**Response to the Required Amendments  
in the Authority's Final Decision**

**Western Power's amended proposed Access  
Arrangement for the Network of the South  
West Interconnected System**

Submitted by Western Power  
2 April 2007

**Figure 1 - Transmission Services Revenue Path**

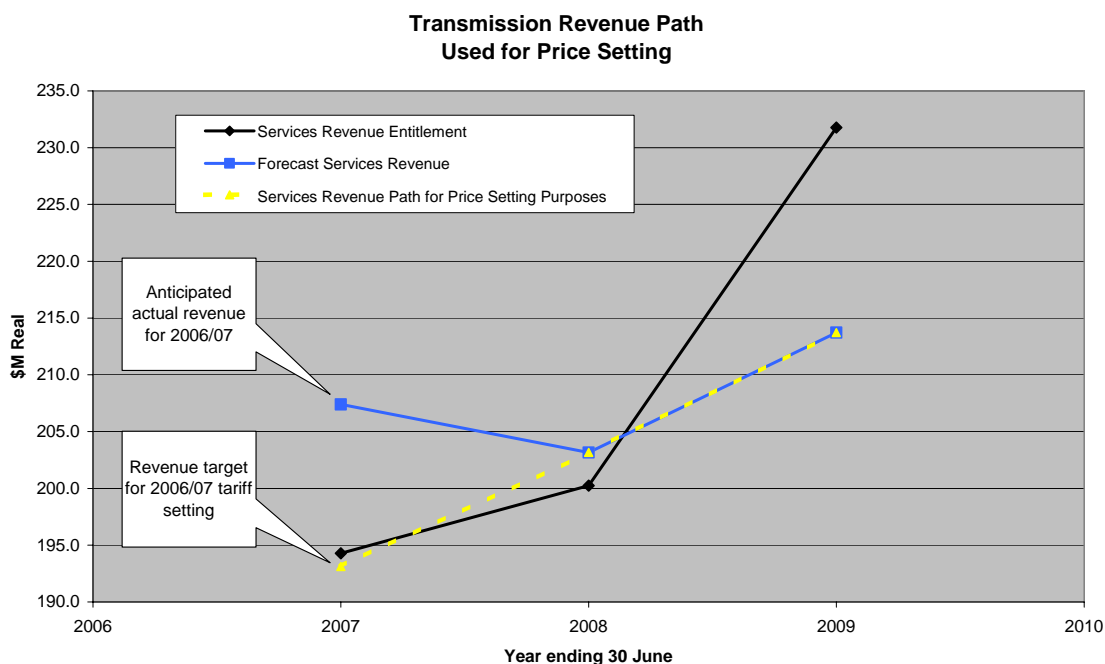
This amendment requires Western Power to amend the price list "to reflect an implementation of the price control that, as far as practical, smooths changes in reference tariffs across the access arrangement period".

The Authority's concern, as articulated in Paragraphs 644 and 645 of the Final Decision, is that whilst tariffs have been smoothed in relation to expected increases in 2007/08 and 2008/09, the smoothing process has not been applied to 2006/07 with the result that some tariffs would be subject to significant increases.

Western Power believes that these desired outcomes are now effectively achieved in this amended proposed Access Arrangement, as explained below. (Note: For the sole purpose of this explanation, "services revenue" is defined as total target revenue minus capital contribution revenue.)

- 1) As a result of the delay in commencement of the Access Arrangement and application of new tariffs, Western Power's actual services revenues will be substantially different to the services target revenue in this financial year, resulting in estimated K-factors of approximately \$13.1M (real \$) over recovery for transmission and \$48.2M (real \$) under recovery for distribution.
- 2) The revenue caps have increased significantly as a result of increases in forecast operating and capital expenditure as explained in Western Power's section 51 submission dated 26 September 2006.

The consequent transmission and distribution "services revenue" are shown in the following graphs, noting that the 2007 values of "forecast services revenue" are the anticipated actual revenues for the 2006/07 financial year.

The “services revenue path for price setting purposes” represents planned average annual revenue increases of CPI+3% for both transmission and distribution. This rate of increase and the 2006/07 tariff settings have been chosen, in combination, as an optimal “best fit” which provides:
